ECE/TRANS/WP.29/GRSP/2009/15
23 September 2009

REGULATION No. 17
(Strength of seats)

Alignment with gtr No. 7 (Head restraints)

Submitted by the Chairperson of the Working Party on Passive Safety */

Figure 1. Non-use warning labels

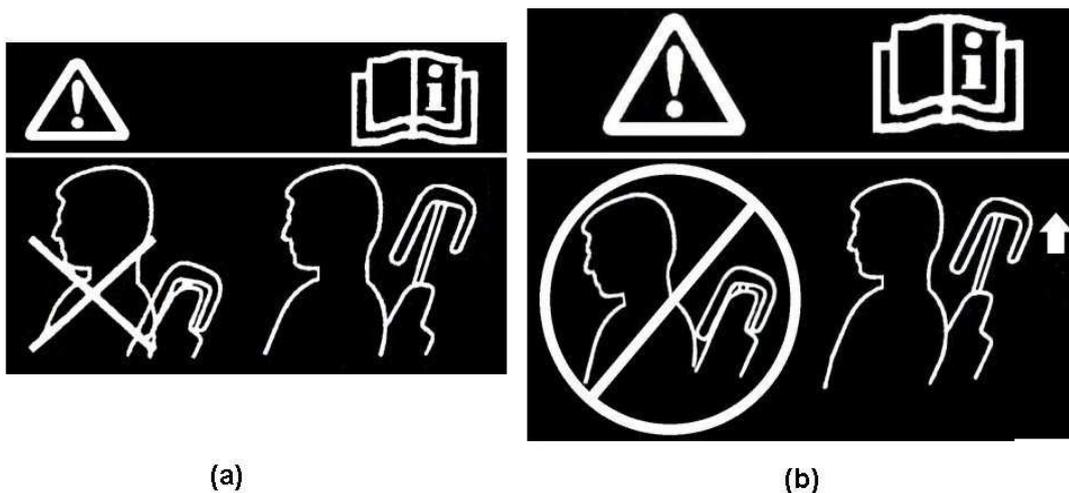
- 5.8.4.5.** The head restraint shall be marked with a label in the form of a pictogram which may include explanatory text. The label shall either provide an indication when the head restraint is in a non-use position or provide information to enable an occupant to determine whether the head restraint is in a non-use position. The label shall be durably affixed and located such that it is clearly visible by an occupant when entering the vehicle to the designated seating position. Examples of possible designs of pictograms are shown in Figure 1.

Figure 1-1

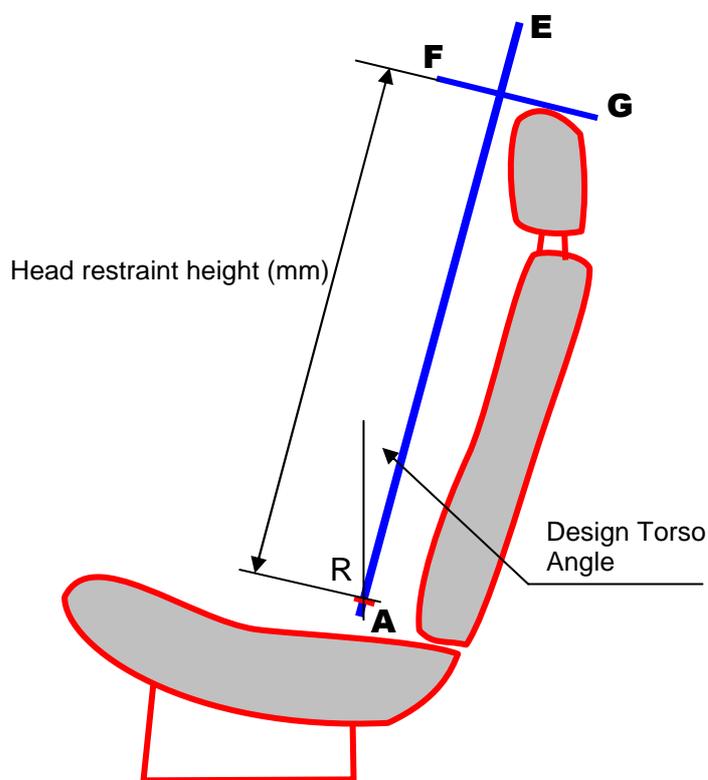
The height measurement apparatus consists of (see Figure 1-1):

2.4.2.1. If adjustable, adjust the head restraint to its maximum height and measure the clearance between the top of the head restraint or the seat back at all seat back angles for intended use and the interior surface of the roofline or the rear backlight, by attempting to pass a 25 ± 0.5 mm sphere between them. In the case of convertibles, the diameter of the sphere shall be 50 ± 0.5 mm.

Figure 2-1

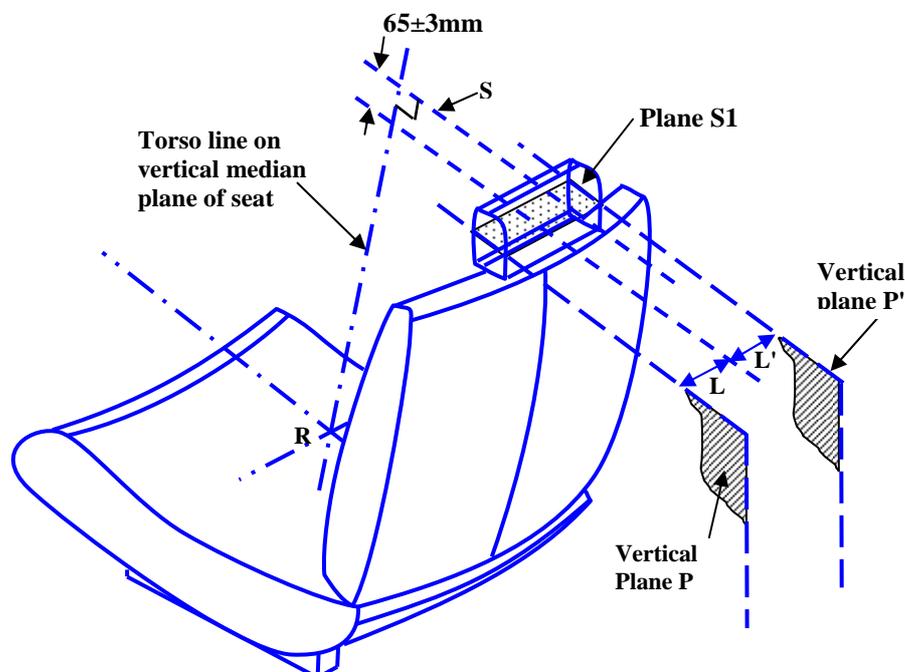
2.2. The plane S1 is a plane perpendicular to the reference line and situated 65 ± 3 mm below the top of the head restraint.

2.3. Planes P and P' are vertical longitudinal planes, tangent to each side of the head restraint to be measured.

2.4. Measure the distances L and L' in the plane S1 between the vertical longitudinal planes passing through the torso line and the planes P and P'.

Figure 3-1 - Measurement of a horizontal gap "a".

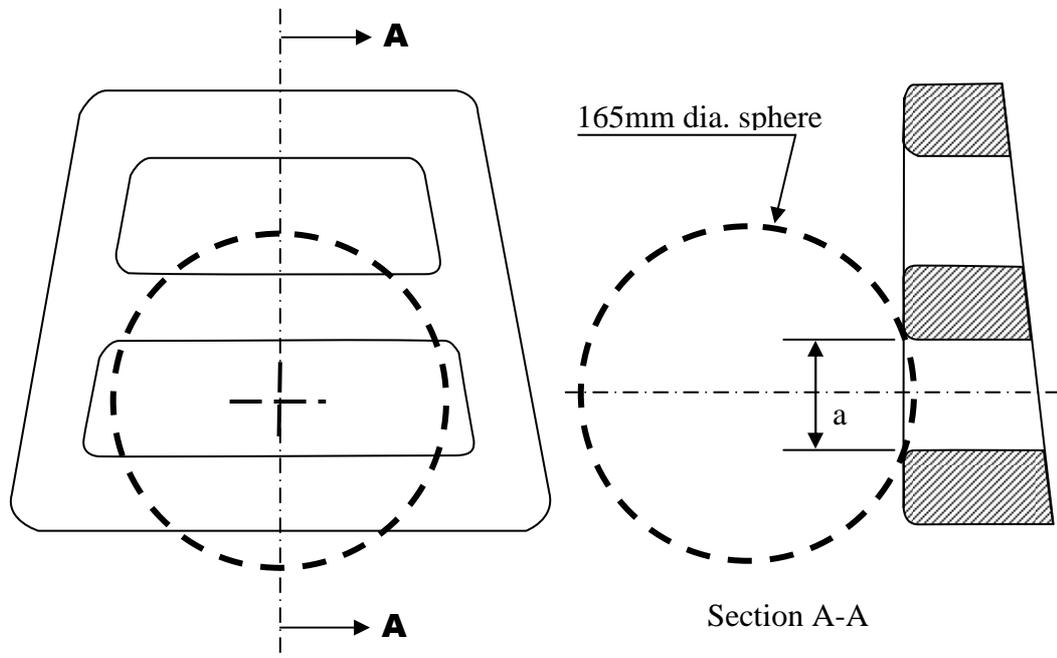
- 2.6.** For gaps within the head restraint, not exceeding 60 mm, no further measurements shall be made.

- 2.7. For gaps within the head restraint, exceeding 60 mm, in order to demonstrate compliance with the requirements of paragraph 5.6.4. of this Regulation, the seat back displacement test procedure described in Annex 6 shall be performed, by applying to each gap, using a sphere of 165 mm in diameter, a force passing through the centre of gravity of the smallest of the sections of the gap, along transversal planes parallel to the torso line, and reproducing a moment of 373 Nm about the R-point.

Figure 3-3

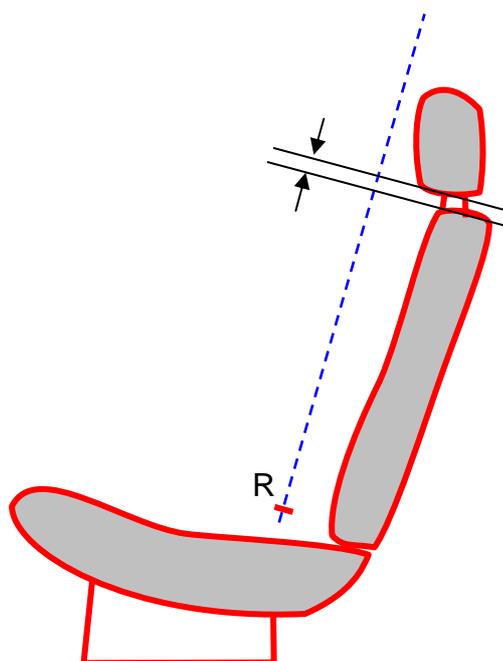
3.3. The gap shall be measured as the perpendicular distance between two parallel planes, described as follows (see Figure 3-3):

- (a) each plane shall be perpendicular to the design torso line;**
- (b) one of the planes shall be tangent to the bottom of the head restraint;**
- (c) the other plane shall be tangent to the top of the seat back.**

Figure 4-1

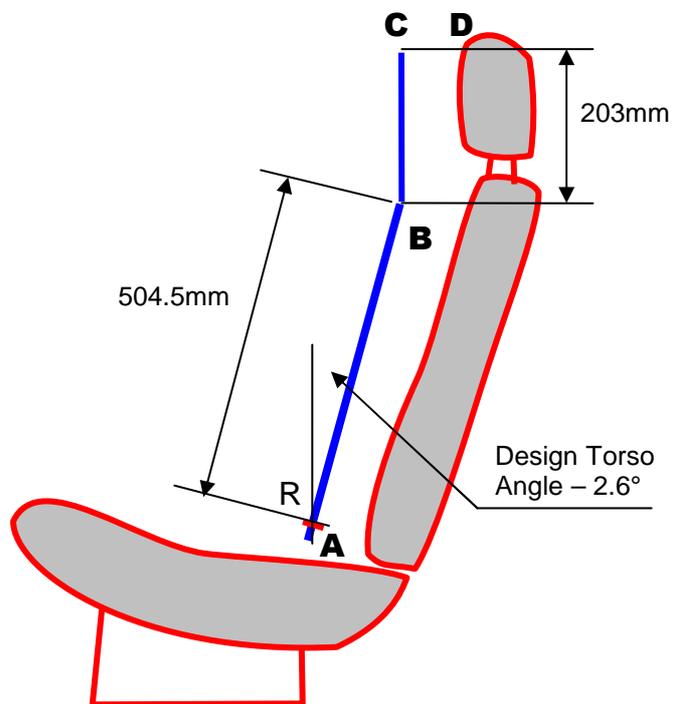
The backset measurement apparatus consists of (see Figure 4-1):

- 3.6. Establish point D on the head restraint, point D being the intersection of a line drawn from point C horizontally in the x-direction, with the front surface of the head restraint.**

- 3.7. Measure the distance CD. The backset shall be the measured distance CD minus 71 mm.

Figure 6-1.

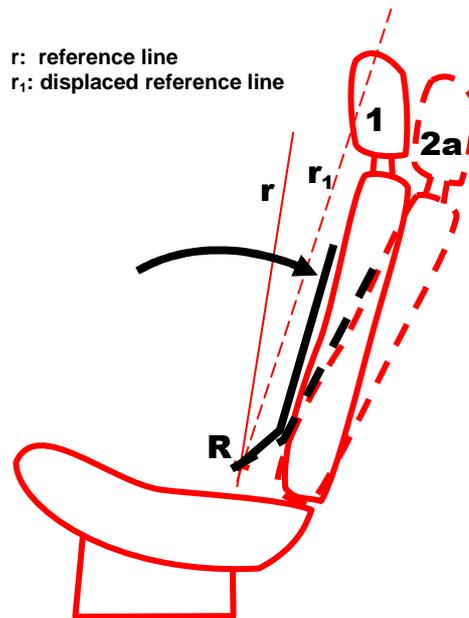
2.3. Establish the displaced torso reference line 'r1' by creating a rearward moment of 373 ± 7.5 Nm about the R-point by applying a force to the seat back through the back pan at the rate of 2.5 Nm/second to 37.3 Nm/second. The initial location on the back pan of the moment generating force vector has a height of $290 \text{ mm} \pm 13 \text{ mm}$. Apply the force vector normal to the torso reference line and maintain it within 2 degrees of a vertical plane parallel to the vehicle longitudinal centreline. Constrain the back pan to rotate about the R-point. Rotate the force vector direction with the back pan. (see Figure 6-1)

Position 2a. Displaced position by applying to the manikin's back a moment of 373 ± 7.5 Nm about the R-point, defining the position of the displaced torso reference line 'r₁'.

Figure 6-2.

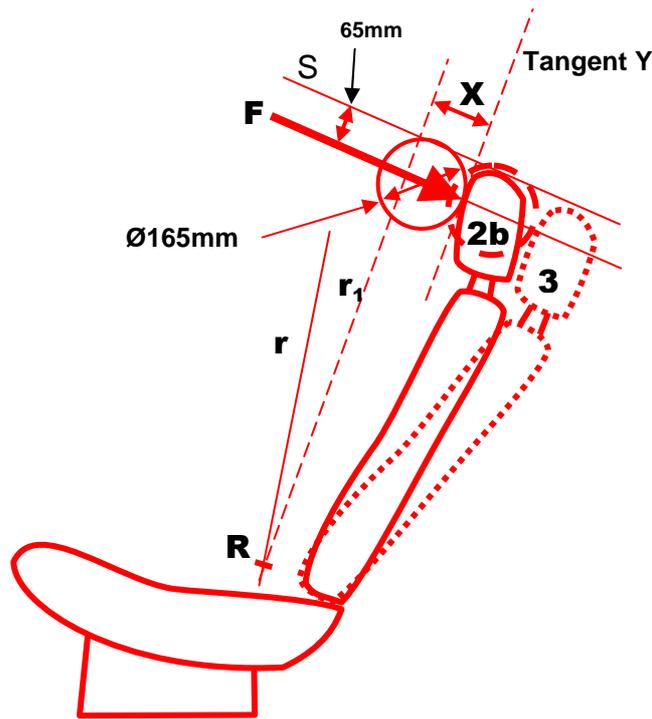
- 2.4. Maintain the position of the back pan as established in paragraph 2.3. of this annex. Using a 165 ± 2 mm diameter spherical headform establish the headform initial reference position by applying, perpendicular to the displaced torso line, a rearward initial load at the seat centreline at a height 65 ± 3 mm below the top of the head restraint that will produce a 373 ± 7.5 Nm moment about the R-point. Maintain this moment for at least 5 seconds and then record the rearward displacement of the headform with the load applied.**
- 2.5. When determining the rearward displacement for head restraints at a gap greater than 60 mm in accordance with paragraph 5.6.4 of this Regulation, the above load shall be applied through the centre point of the smallest of the sections of the gap, along transversal planes parallel to the torso line (see Figure 6-2).**

Figure 9-1 Video motion target placements

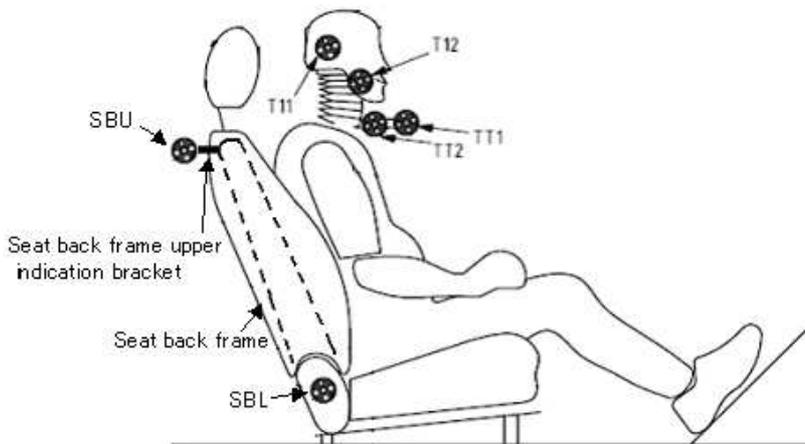
3.3.1. Film targets, as described in Figure 9-1 and Table 9-1, shall be applied on the head, T1 bracket, seat back frame upper indication bracket and seat back recliner or lower part of the seat back frame lower, at the side which the test institutes in consultation with the manufacturer considers to be more appropriate for the test.

Figure 9-2 Proper positioning of the test dummy's feet.

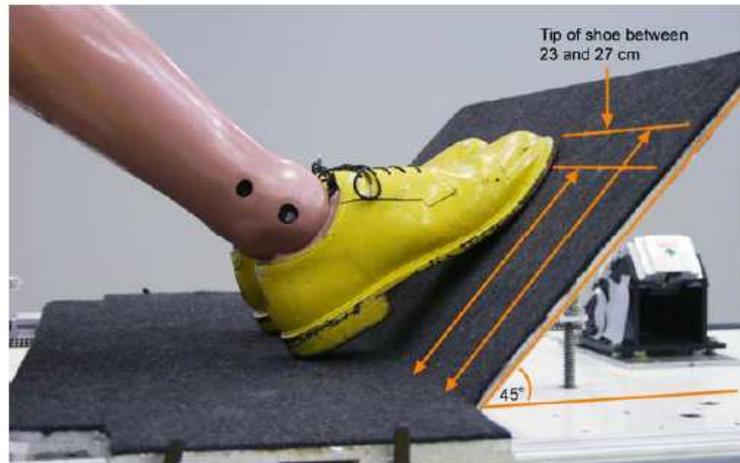
- 4.4.8. Adjust the test dummy's feet and/or the horizontal position of the adjustable toe board so that the heel of the test dummy's shoe is resting on the heel surface. The tip of the shoe shall rest on the toe pan between 230 mm and 270 mm from the intersection of the heel surface and toe board, as measured along the surface of the toe board (see Figure 9-2).

Figure 9-3 Spine curvature check

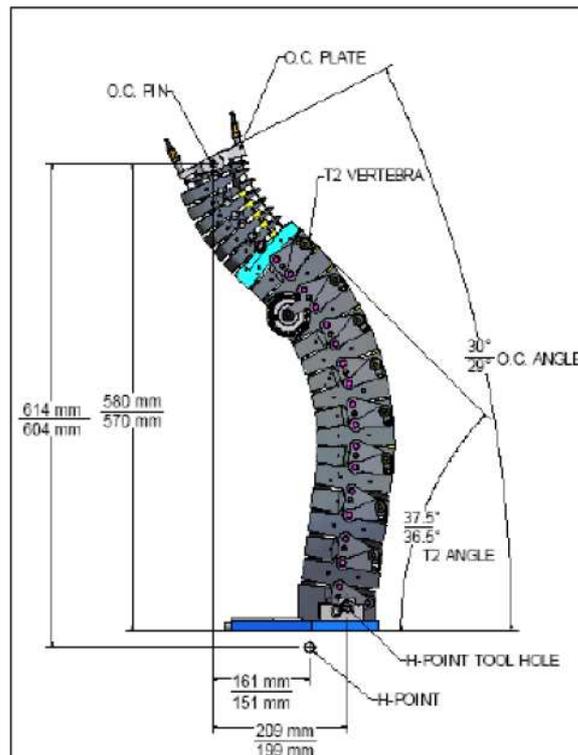
With the pelvis adapter plate placed on a level surface, the spine stature shall meet the specifications defined in Table 9-2 and Figure 9-3. The curvature check shall be performed after every 15 tests and all measurements shall be recorded and fully documented.

Figure 9-4 Sled pulse

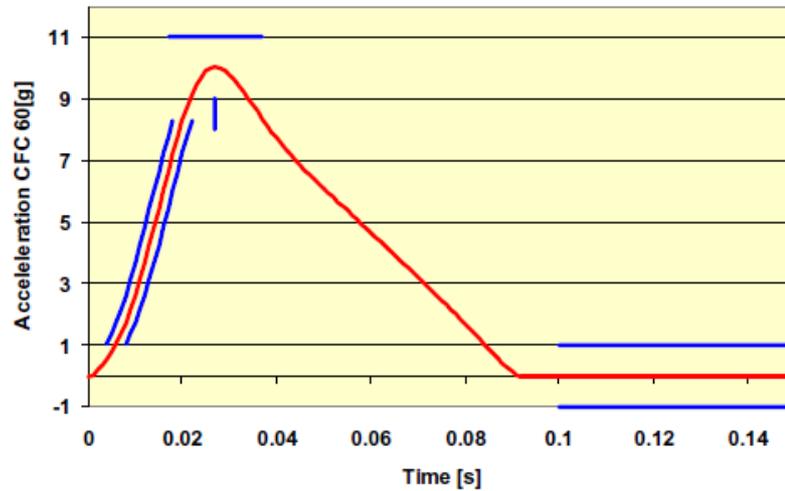
- 5.1. The corridors for the pulse are illustrated in Figure 9-4. The sled acceleration shall be adjusted within the corridors in Table 9-3 for the complete time interval from 0 to 0.15s. The sled pulse shall fulfil the requirements as specified in Table 9-4.

Figure 10-1.

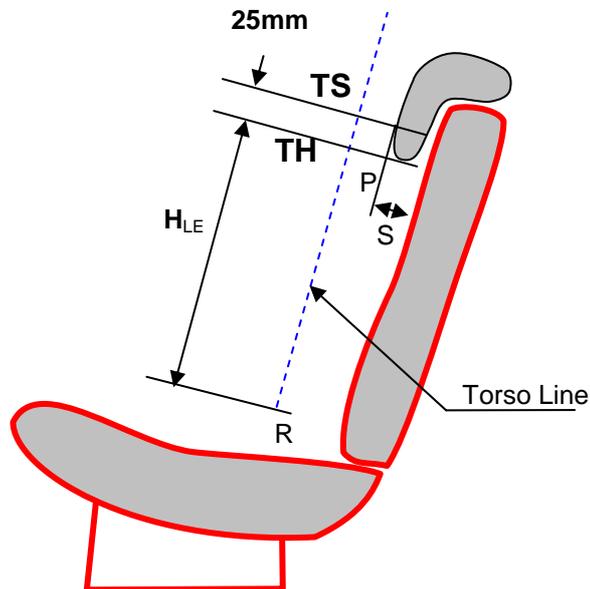
4.1. The HLE and S dimensions are defined in Figure 10-1 which shows a vertical fore-aft plane passing through the R-point (i.e. at the mid point of the designated seating position) intersecting the seat cushion, seat back and the head restraint.

4.2.4. TH is the line perpendicular to the torso line and tangent to the lower edge of the head restraint.

4.2.5. TS is the line parallel to and 25 mm from TH.
